**Boston Overflight Noise Study (BONS)
BOS/TAC Meeting**

MEETING SUMMARY

March 30, 2006

Date: March 20, 2006
To: Boston Technical Advisory Committee (BOS/TAC)
From: Project Consultant (PC) _____
Subject: Alternative 5 – Runway 22R/L RNAV Departures

Exhibit 1

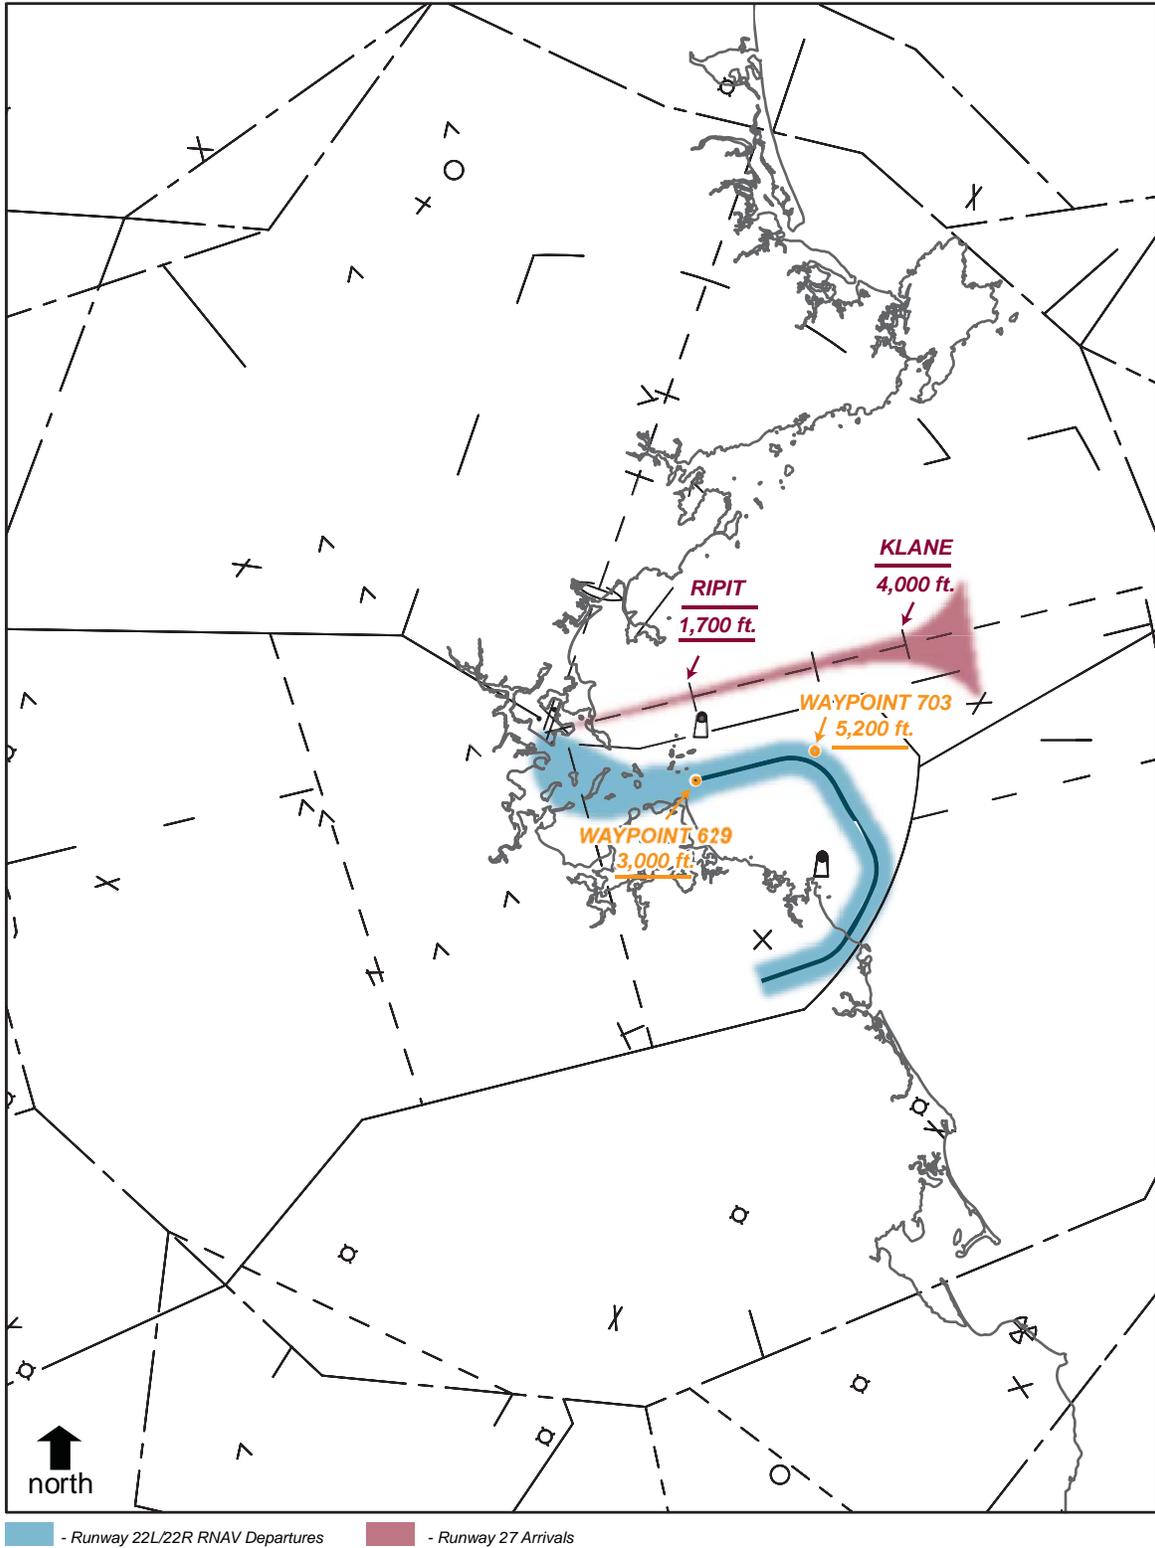
Steve Smith explained that at the February meeting, the PC presented what it believes was the best available design based on airspace and design, and one that met the intent of procedure. The issue that was raised at the meeting was the location of waypoint 629, and its viability in terms of separation from 27 arrivals and its relationship to northern tip of Hull. Steve Lathrop had inquired as to what waypoint 629's impact was given the 3.5 mile lateral separation with the approach to 27. Robb Varani's findings had been that the waypoint could only be moved 0.2 nautical miles to the south without impacting the remaining elements of the design. Anything more than 0.2 would put the waypoint outside the departure sector and impact TRACON to Center transition. The PC still had concerns that even moving the waypoint 0.2 miles would not meet the FAA's desired 3.5 nautical miles between the center of 22 RNAV and center of 27's approach.

S. Lathrop said that he was confused. He said the memo stated that the procedure cannot be redesigned to meet FAA separation requirements, but then R. Varani had referred to the 3.5 mile separation. S. Smith replied that FAA was concerned about the center line. He explained that there is a 0.6 nautical mile width on either side of the center line. S. Lathrop asked if there was an expectation that the northern edge of the dispersion corridor would be 3.5 miles to the north if flights meet standards. S. Smith corrected his statement that the 3.5 mile separation starts from the northern edge of the RNAV procedure as discussed at the February 17th meeting. S. Lathrop suggested that there was agreement that this is a requirement. Dennis Burke replied that they were looking at it from the point of view of trying to get 3.5 miles of lateral separation. The refinement proposed by PC incorporates a vertical separation as well as staying 1.5 miles south of the departure sector line that separates Runway 27 arrivals from Runway 22 departures. The PC believes this is practical depending on how the procedure comes out of FAA's 18-step process. There was uncertainty due to the fact that this will be one of the first procedures of this kind to be reviewed. D. Burke suggested that, in the PC's opinion, this is on the only opportunity to put an RNAV procedure for runway 22 into the 18-step process with a chance to come out on the other side as an approved procedure. It can't be moved north because of 27 and it can't be moved south because it will go against the goal of reducing flight tracks over Hull. As a result, as per the March 20th memo, the PC is recommending that this procedure go into noise analysis.

Two observable modes have contributed to the above observation: (Mode 1) airplanes turn eastward from the 140 degree departure heading early (or seem not to use it at all), and then fly far to the north of the first waypoint, sometimes missing it by a mile or more; (Mode 2) airplanes fly close to the first waypoint, typically by first flying north of George's Island, and then angling southeastward toward the waypoint on a heading which also brings them close to Point Allerton. This course makes it impossible for these airplanes to approach the second waypoint at all, but easy for them to turn across the Hull peninsula as they proceed westward. Other variations were also seen, but none seemed to match the proposed procedure any better than these two, which were seen repeatedly.

1. The RNAV departure from Rwy 15 seems improvable. It apparently uses the same initial waypoint as Rwy 22 departures would. This is inappropriate because the Rwy 22 waypoint has been located as far south as possible to create lateral separation from presumed Rwy 27 arrivals. Most of the time when Rwy 15 departures occur, (at night)

Rwy 27 is not in use for arrivals. Hence, reliance on the Rwy 22 waypoint risks directing Rwy 15 departures closer to Hull than there is any reason to do. Any RNAV departure procedure from Rwy 15 needs its own initial waypoint, substantially north of the one used for Rwy 22 departures.

- 1) The PC will develop the original Alternative 5, as presented on February 17th, with required altitude crossings for departure aircraft. As shown in the attached exhibit, departure aircraft will cross Waypoint 629 (located 6.3 NM from the end of Runway 22L, approximately 7NM travel distance (latitude: 42° 19' 21.12"/longitude: 70° 52' 30.63")) at or above 3,000 ft. MSL, and Waypoint 703 (latitude: 42° 20' 31.05"/longitude: 70° 45' 53.99") at or above 5,200 ft. MSL. Arrival aircraft will normally be at or below 4,000 ft. MSL turning to the final approach course, and will be required to cross the RIPIT intersection at 1,700 ft. MSL on the approach to Runway 27. This will procedurally provide the required FAA altitude separation of 1,000 ft. MSL between the arrival and departure aircraft while using this procedure. Though there is no known FAA criteria to support the concept of including altitude separation for this procedure, we believe that the 3.4 NM lateral separation from the Runway 27 final approach course that our design provides, in conjunction with the altitude separation provided, would make this alternative design a better candidate to be evaluated in the FAA's 18-step process compared to the original presented February 17th at the BOS/TAC meeting.

- 2) The vector to a fix RNAV design that we propose is based on new criteria developed within the last year. It is subject to interpretation and change, based on discussions with Flight Standards (AFS 420) personnel. The variables that dictate dispersion along the vectored pattern are the same for existing conditions. Controllers will issue a heading to waypoint 629 when radar contact is established and separation is established. Due to weather conditions, piloting and the time when the controller issues the heading, the point at which the turn is conducted is expected to vary. Therefore, PC assumed that the southern dispersion in this first segment of the departure procedure will be similar to existing conditions, but the dispersion on the north side of the corridor will be reduced as the aircraft will be heading towards waypoint 629. The waypoint is a fly-by waypoint, which does not require the aircraft to fly directly over the waypoint. The PC is predicting that traffic will be within the RNAV corridor just after passing waypoint 629. Prior to waypoint 629, in the vector to a fix segment, the dispersion may be narrower than the PC has predicted, but there is no objective means to justify a narrower dispersion at this time for BOS traffic conditions. Therefore, PC has decided to use a wider dispersion to be more
